TRANSMITTAL COVER SHEET

DATE: 21 June, 2024
TO: ALL PLAN HOLDERS OF RECORD
FROM: HUNTER SWATEK, AIA, PROJECT MANAGER
PROJECT: RAINBOW CITY RECREATION CENTER
GMC PROJECT NO. ABHM230021
RE: ADDENDUM NO. 3 AND
ACKNOWLEDGEMENT OF RECEIPT OF ADDENDUM NO. 3

ADDENDUM NUMBER 03

**PROJECT: RAINBOW CITY RECREATION CENTER
GM&C PROJECT NO. ABHM230021**

Scale: 1/4" = 1'-0"

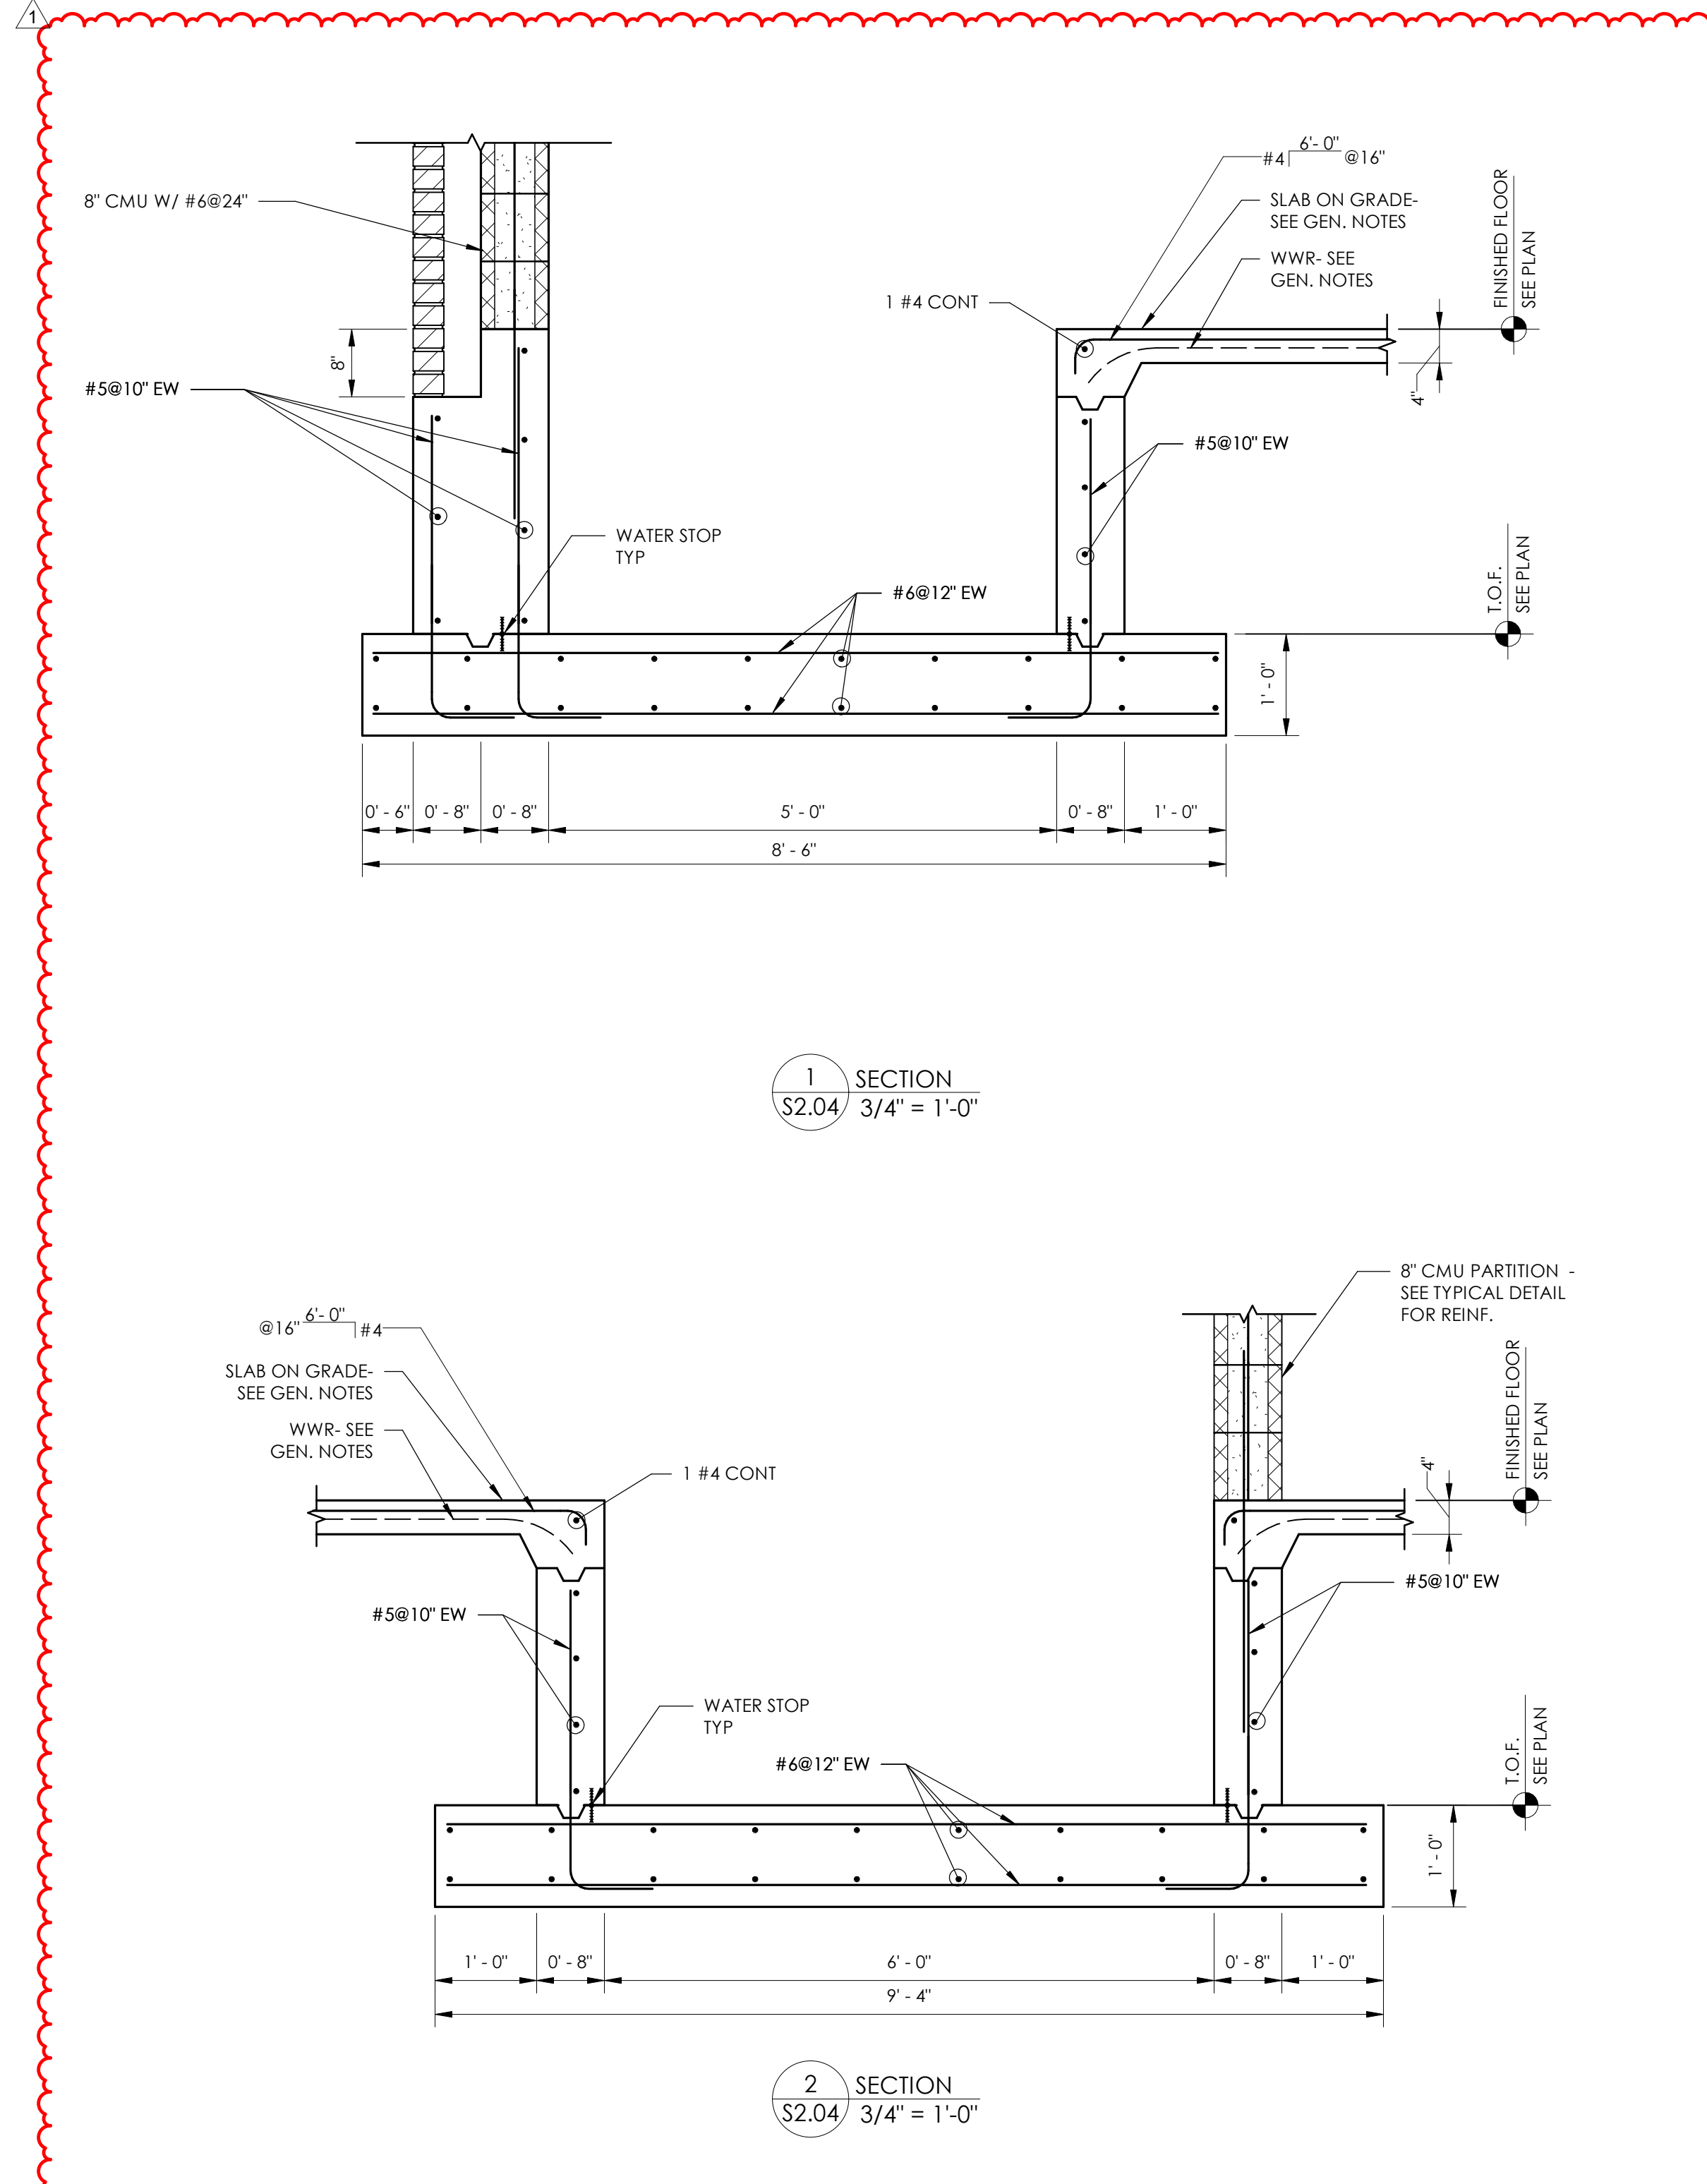
- a. ADDED Partitions and thickened slab
 - b. ADDED Section
- U. **S2.03** – High Roof Framing Plan
 - a. REVISED To match MEP
- V. **S2.04** – Pool Building Plans

- a. REVISED Partitions and thickened slab
 - b. ADDED Sump pits
- W. **S2.05** – Amphitheatre Plans
 - a. ADDED Dimensions
 - b. ADDED Section
- X. **S3.01** – Sections
